SUBJECT: ISSUANCE OF AMENDMENT - DAVIS-BESSE NUCLEAR POWER STATION,
UNIT 1 (TAC NO. MA5477)

This amendment revises the Technical Specifications (TSs) to expand the present spent fuel storage capability by 289 storage locations by allowing the use of spent fuel racks in the cask pit area adjacent to the spent fuel pool. The changes include TS 3/4.9.7, "Refueling Operations - Crane Travel - Fuel Handling Building," and associated Bases; TS 3/4.9.11, "Refueling Operations - Storage Pool Water Level"; TS 3/4.9.12, "Refueling Operations - Storage Pool Ventilation"; TS 3/4.9.13, "Refueling Operations - Spent Fuel Pool Fuel Assembly Storage;" and associated Bases; TS 5.6, "Design Features - Fuel Storage"; and related changes to the TS Index.

ATTACHMENT TO LICENSE AMENDMENT NO. 237

SAFETY EVALUATION BY THE OFFICE OF NUCLEAR REACTOR REGULATION

Figure 3.9-1
 Burnup vs. Enrichment Curves For
 Davis-Besse Spent Fuel Pool Storage Racks

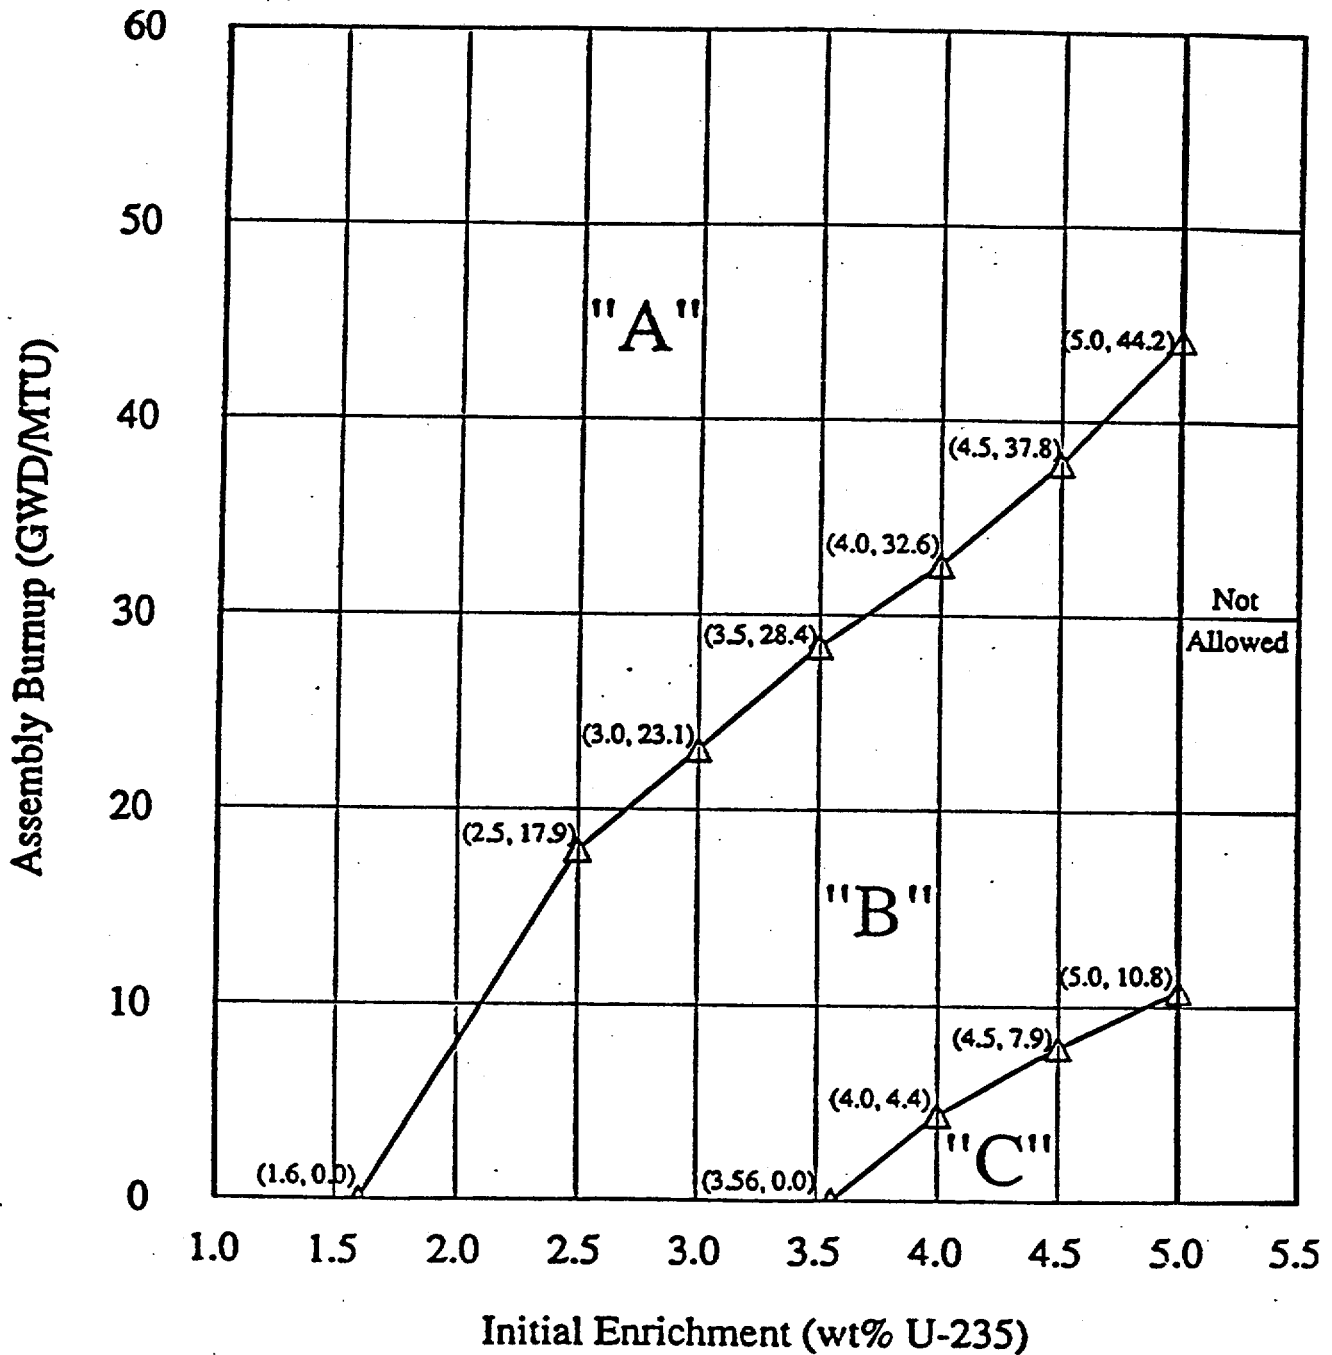
- a. Fuel assemblies stored in the spent fuel pool shall be placed in the spent fuel storage racks in accordance with the criteria shown in Figure 3.9-1.
- b. Fuel assemblies stored in the cask pit shall be placed in the spent fuel storage racks in accordance with the criteria shown in Figure 3.9-2.

Figure 3.9-2
 Burnup vs. Enrichment Curve For
 Davis-Besse Cask Pit Storage Racks

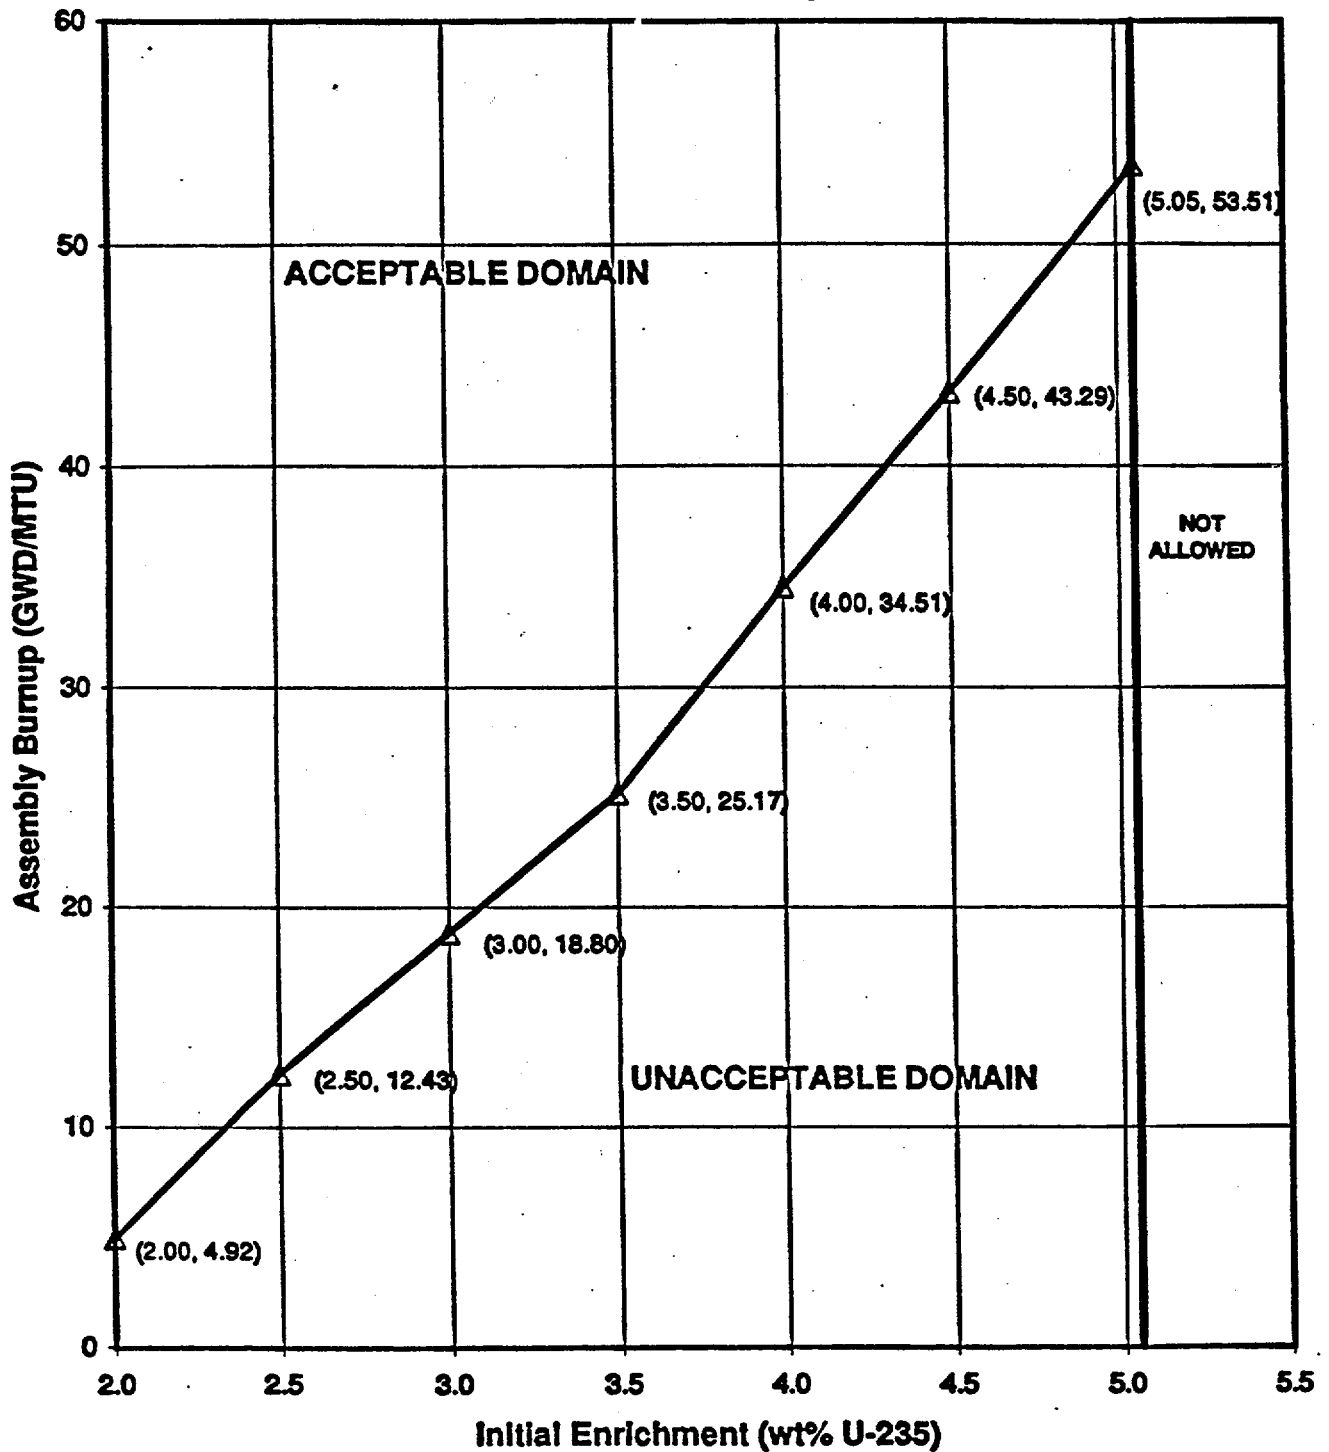
- (4) TS 3/4.9.13, "Refueling Operations - Spent Fuel Pool Fuel Assembly Storage," and related Bases would be revised to reflect the conditions required for fuel assembly storage in the cask pit area. The associated Figure 3.9-2, which shows the minimum required fuel assembly burnup as a function of initial enrichment for allowed storage in the cask pit racks, would be added.

- (1) For criticality consideration, the SFA must meet a minimum burnup restriction which is a function of initial enrichment as specified in the proposed TS Figure 3.9-2, "Burnup vs. Enrichment Curve for Davis-Besse Cask Pit Storage Racks," before the SFA will be allowed to be stored in the cask pit storage racks.
- (2) For thermal-hydraulic consideration, the SFA must not exceed a maximum heat generation rate restriction of 873 watts. A SFA will not be allowed to be stored in the cask pit storage racks if this maximum heat generation rate is exceeded.
- (3) For radiological consideration, the SFA must meet a restriction of 3 years minimum decay time since last irradiation. A SFA will not be allowed to be stored in the cask pit storage racks if this irradiation restriction is not met.

The final maximum calculated reactivity resulted in a k_{eff} of 0.9452 for 5.05 w/o U-235 fuel at a burnup of 53,510 megawatt days per metric ton uranium (MWD/MTU), when combined with all known uncertainties. This value meets the staff's criterion of k_{eff} no greater than 0.95 including all uncertainties at the 95/95 probability/confidence level. Therefore, the proposed storage of fuel enriched to 5.05 w/o U-235 in the racks installed in the cask pit is acceptable if it meets the burnup versus initial enrichment curve given in TS Figure 3.9-2.
